# **KINCOPPAL ROSE BAY**

Submissions Report  
SSD-10325

Prepared for  
**KINCOPPAL ROSE BAY SCHOOL**  
July 2021

Figure 2 – Extract of Existing and Proposed Car Parking Spaces (ELC and Junior School)

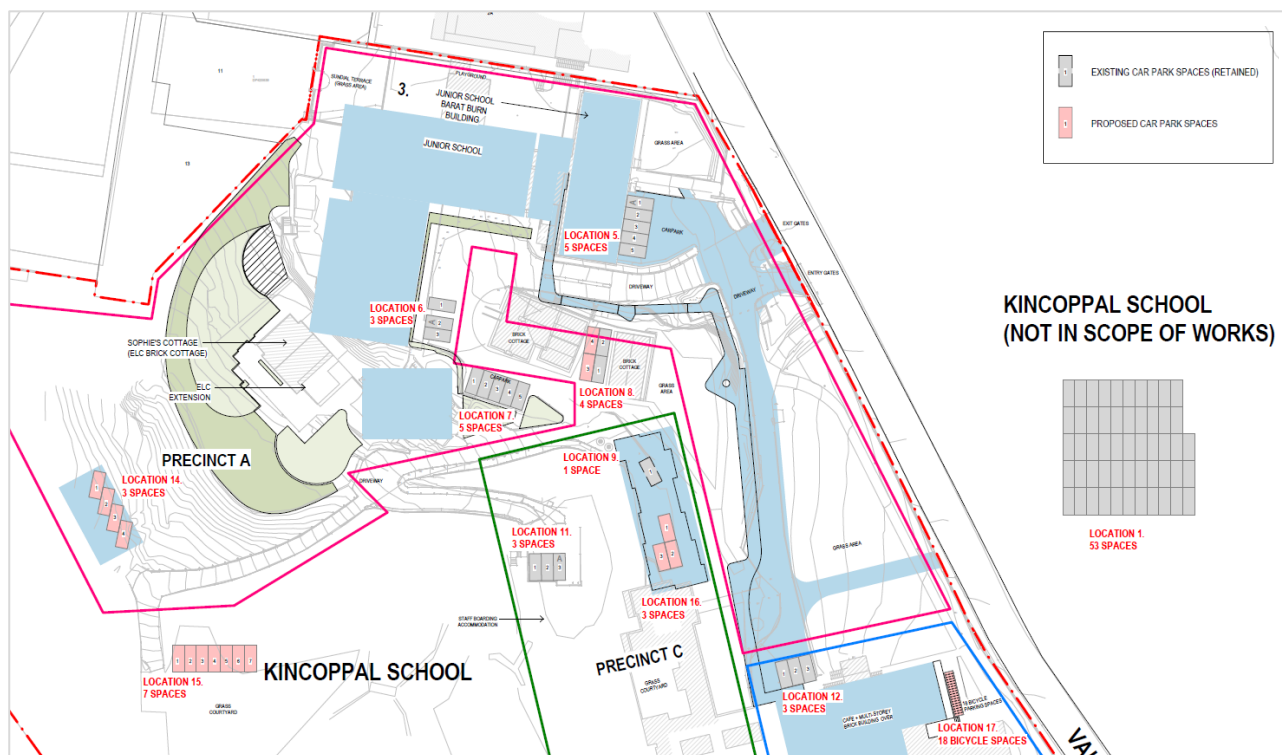
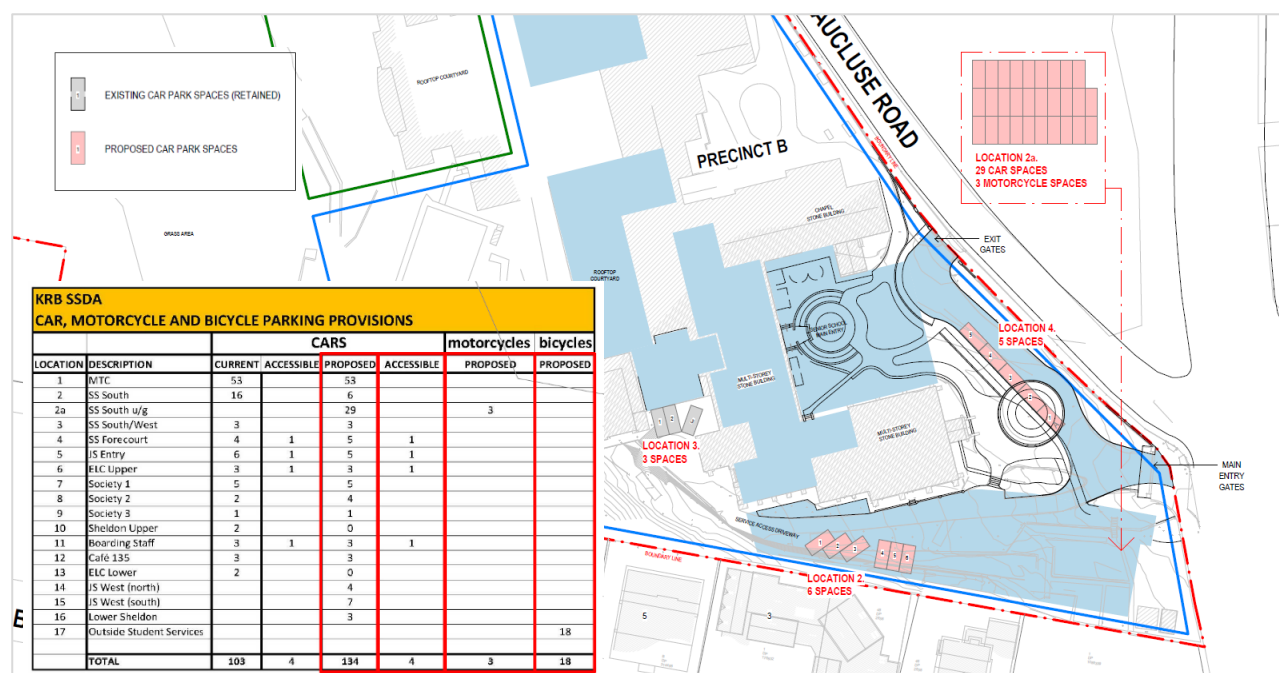
In Woollahra Council's submission, it was noted that the proposal as originally submitted did not provide adequate car parking, motorcycle parking and bicycle parking on site in accordance with the *Woollahra Council Development Control Plan 2015* (Woollahra DCP 2015) and the *RMS Guide to Traffic Generating Developments*.

In response to Council's submission, the proposal has been refined since public exhibition to comply with the relevant parking requirements. An additional three (3) car parking spaces will be provided on site to address the shortfall identified in Council's submission. This results in an overall provision of 31 car parking spaces on site (including four accessible car parking spaces) that will be delivered as part of the proposed development. The provision of these spaces will form part of the Stage 1 Application for detailed works, although will be constructed to align with the various sub-phases identified in **Table 7** below.

A total three (3) motorcycle spaces will also be provided within the Bus and Car Parking Area (as part of Phase B-1), and 18 bicycle parking spaces will be delivered adjacent to the Year 8 Learning Centre (as part of Phase B-2). This meets the relevant parking requirements of the Woollahra DCP and the *RMS Guide to Traffic Generating Developments*.

The proposed location of additional car parking, motorcycle parking and bicycle parking is illustrated in **Figure 2** and **Figure 3** below.

Figure 4 – Tree Management Plan (Sheet 01)

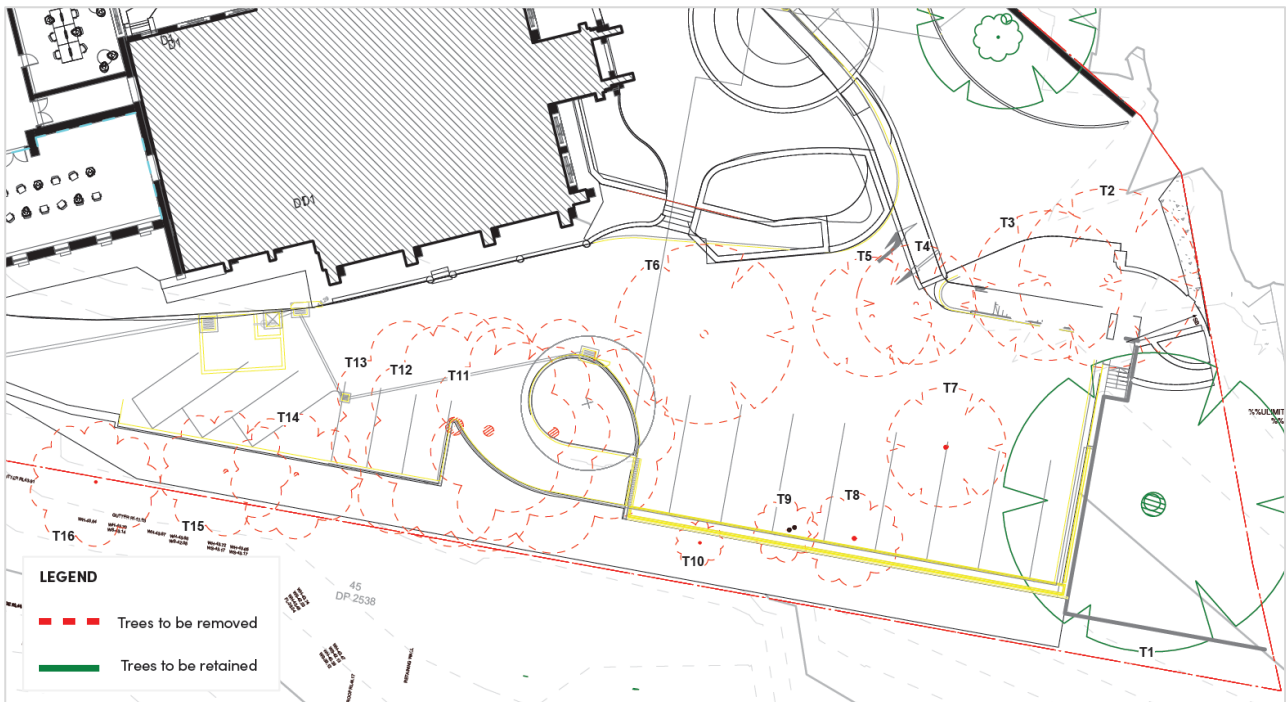
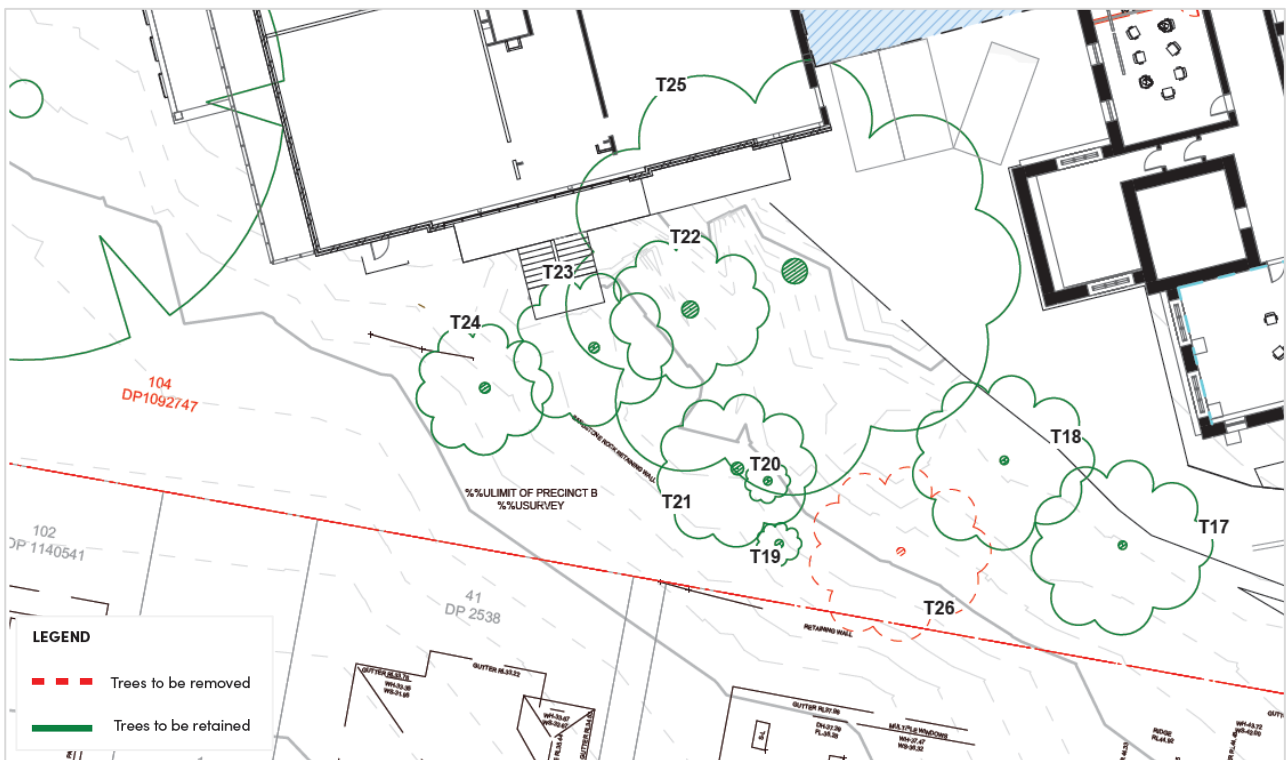
It is also understood that Council does not support the removal of Trees 4-6 and 11-13, and that further consideration should be given to alternative design approaches to potentially facilitate the retention of these trees. A response to the issues raised relating to tree removal and the design and layout of the Bus and Car Parking Area is provided in the following section.

- Consideration was also given to relocating the Bus and Car Parking Area slightly further to the south from its current position. However, the proposed landscape buffer along the southern boundary that is included as part of the revised proposal would be compromised. This would also result in unacceptable impacts to visual and acoustic privacy to the neighbouring properties to the south.
